U.S. Environmental Protection Agency
Pacific Southwest - Region 9
Clean Air Act Permit

Response to Public Comments on Proposed Prevention of Significant Deterioration Permit

**Palmdale Energy Project
PSD Permit No. SE 17-01**

April 2018

Figure 1 Renewable Energy Generation within the California ISO on November 26, 2017

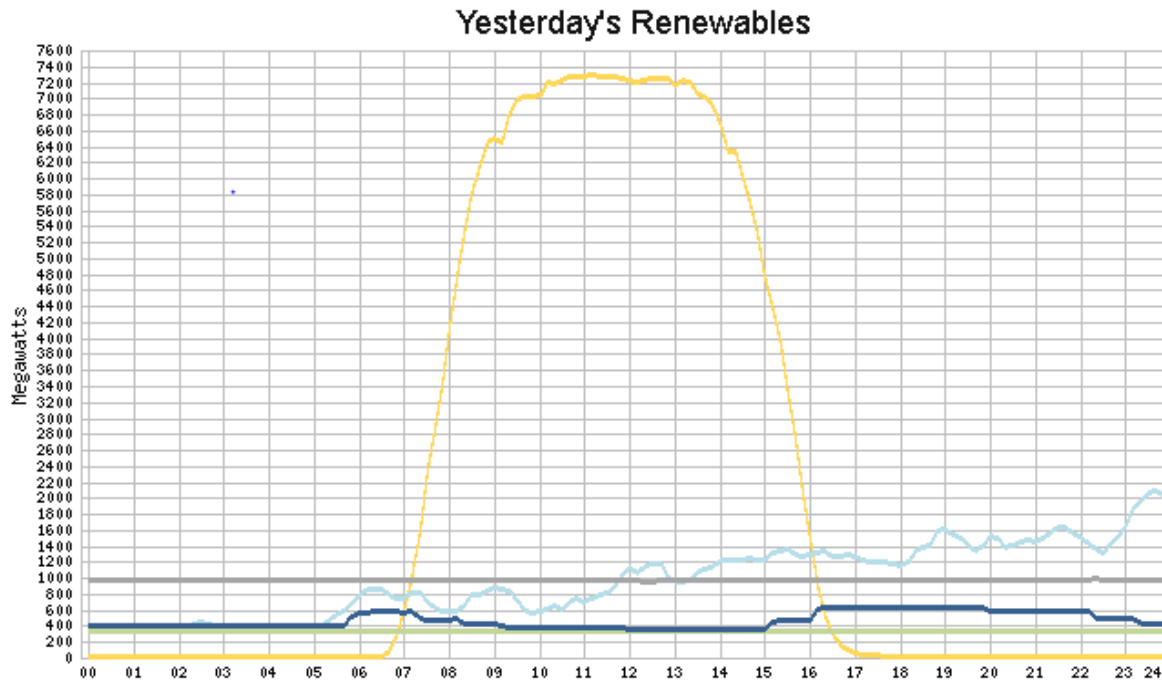
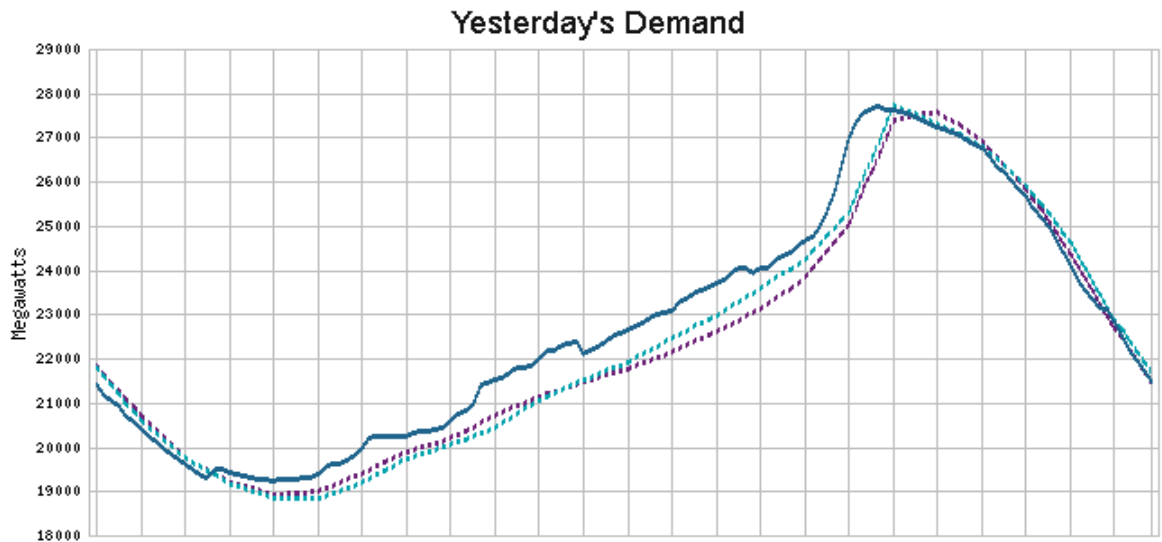
significant amounts of energy during these types of demand fluctuations that can last for numerous hours. None of the projects suggested by the commenters are able to meet this type of need.²⁰

Figure 3 Maximum Project-Only Impacts for 1-hr CO, 8-hr CO, and Annual NO₂

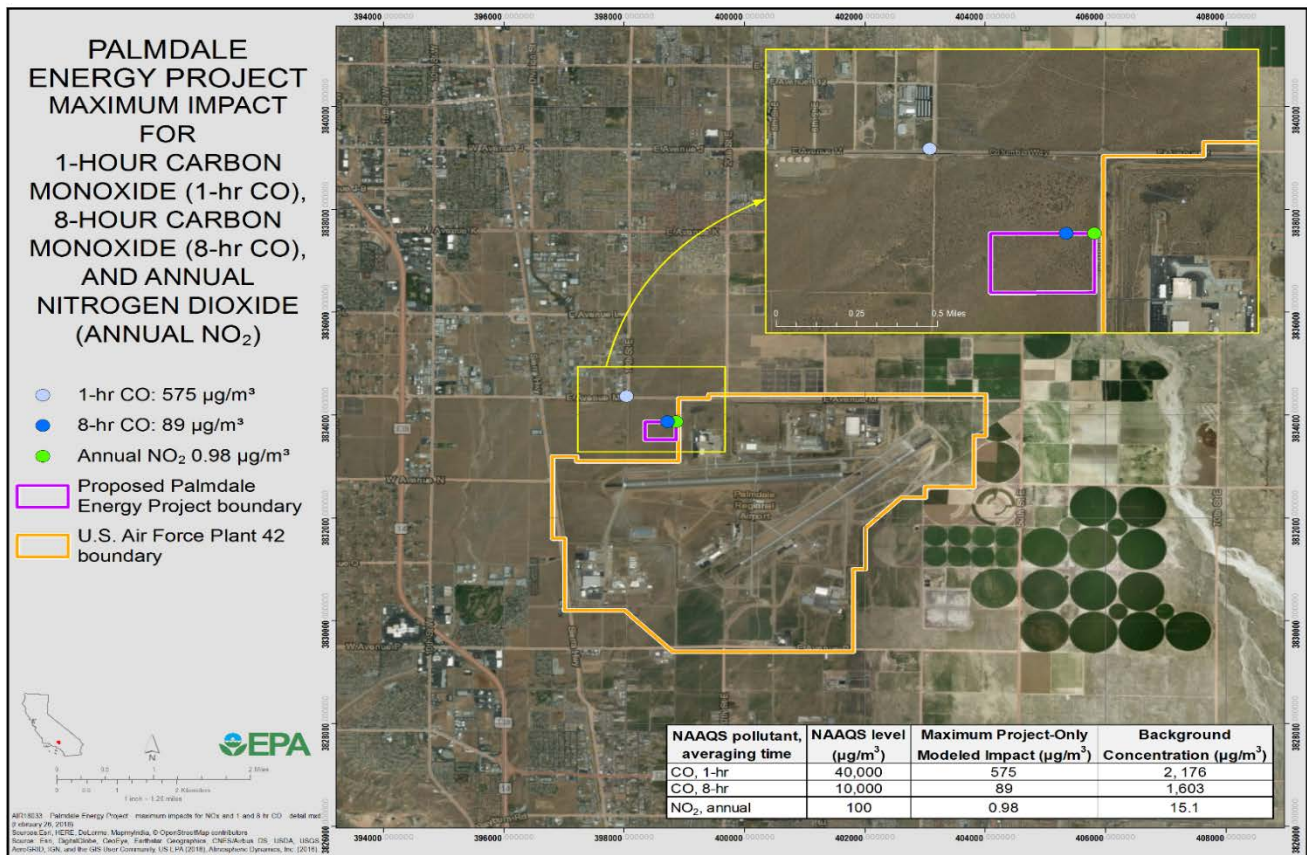
In response to the commenters' concerns regarding Figures 8-11, we note that Figures 8-10 in the Fact Sheet displayed a visual representation of the results of the additional cumulative impacts modeling, which did not include Plant 42 receptors, as discussed above. The PEP's impacts within Plant 42 were included in the preliminary modeling, as discussed above. We had initially planned to provide a visual representation of the complete set of air quality modeling conducted for our cumulative analyses that would include both the Plant 42 portion of the Project-only modeling results with the cumulative modeling results outside the Plant 42 boundaries. However, it became evident, particularly with respect to 1-hr NO₂ where a much more conservative modeling analysis was performed for Project-only impacts, that combining the two sets of modeling results in one visual representation would have been difficult and made the representation of impacts more confusing to understand. As included in

the Fact Sheet, our intent in Figures 8-11 was to show consistent information in each figure by including only modeled impacts outside of Plant 42. The figures were not intended to represent all of the modeling results. The text of the Fact Sheet described the complete set of preliminary and cumulative modeling conducted, and Tables 24 and 25 presented the maximum values from the modeling. We now recognize the figures could have been explained more clearly in the Fact Sheet. And, as the commenters highlight, Figure 11 inadvertently included the Plant 42 portion of the Project-only modeling results along with the results of the cumulative impacts analysis for the area outside of Plant 42. In further response to the commenters, the basis for excluding Plant 42 receptors in the additional cumulative modeling (while including them in the preliminary modeling) was stated in the Fact Sheet at p. 74, as discussed above. Nonetheless, our air quality impact determination is based on the *maximum* modeled impacts which were included in Tables 24 and 25 of the Fact Sheet. And, as stated above, all of the Applicant's modeling data were made available during the public comment period, which identified each receptor modeled and the resulting impacts for each modeling analysis.

Figure 4 CO Emissions During Fluctuating Load Conditions

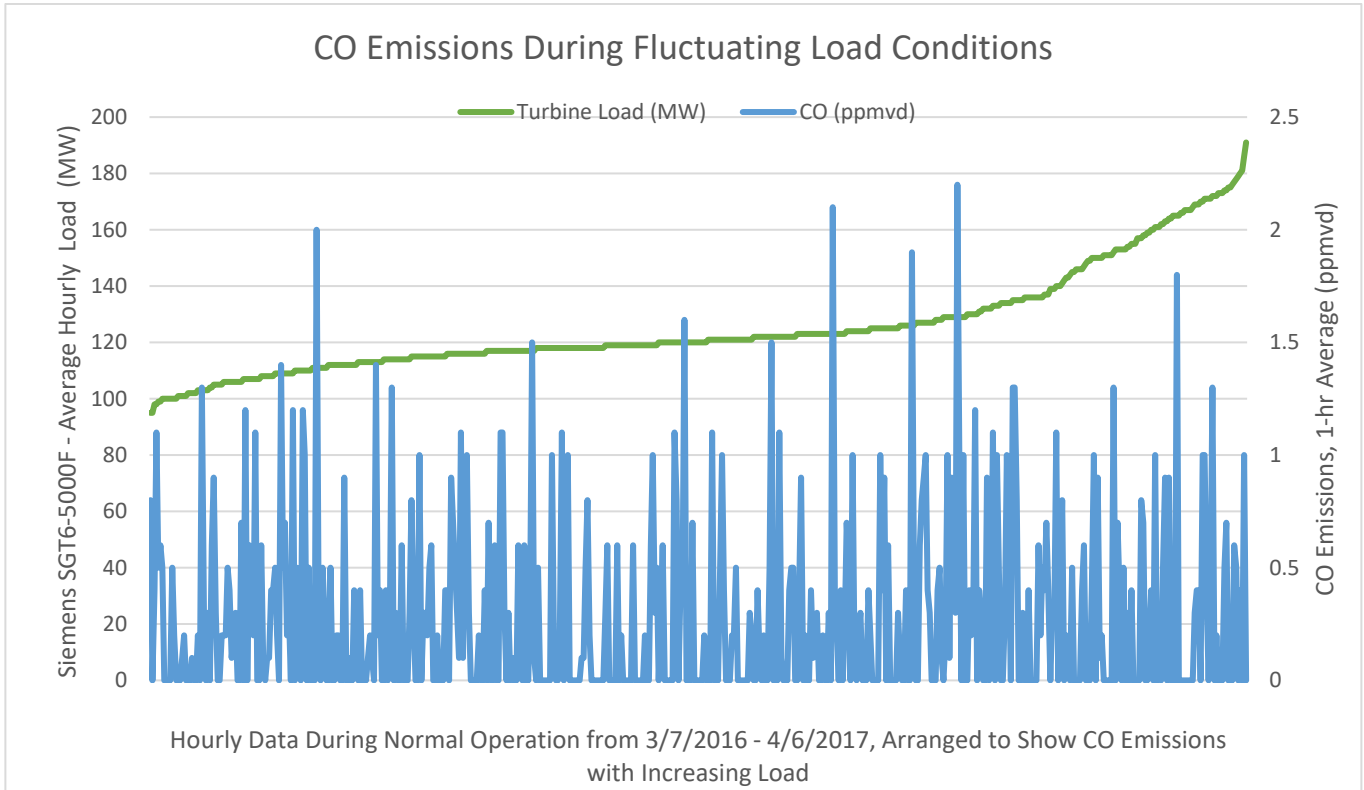
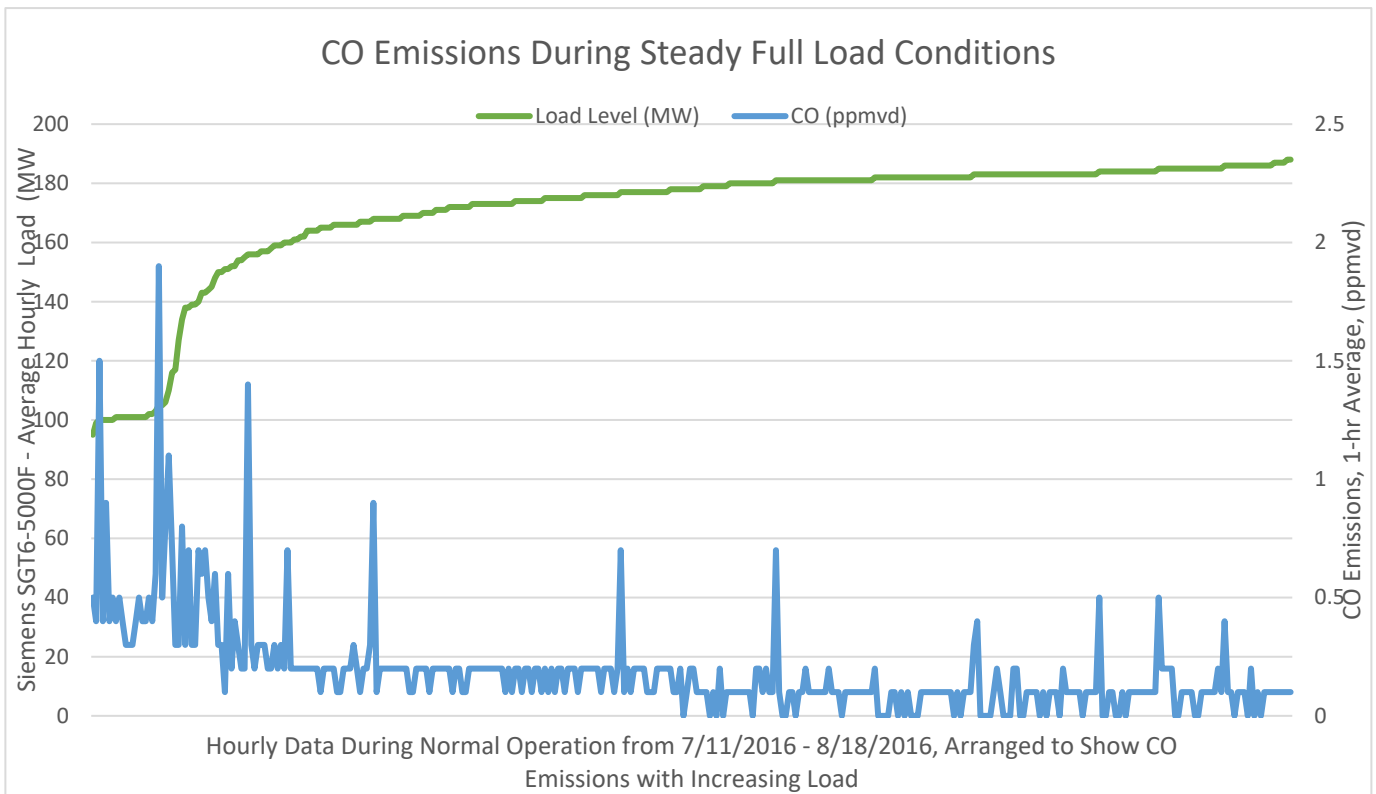
As seen in Figure 4, during fluctuating load conditions, CO emissions appeared to be erratic, routinely spiked above 1 ppm, and in a few instances, were at or above the unit's 2.0 ppm limit. Further, the CO emissions did not appear to become less erratic as load increased, indicating that CO emissions in this particular range are not solely a function of the load level. As seen in Figure 5, during near full load, steady conditions, emissions were almost always below 1 ppm. Emissions only spiked above 1 ppm and became erratic during those few instances when the unit operated below 160 MW, at which point the emissions became similar to those seen in Figure 4.
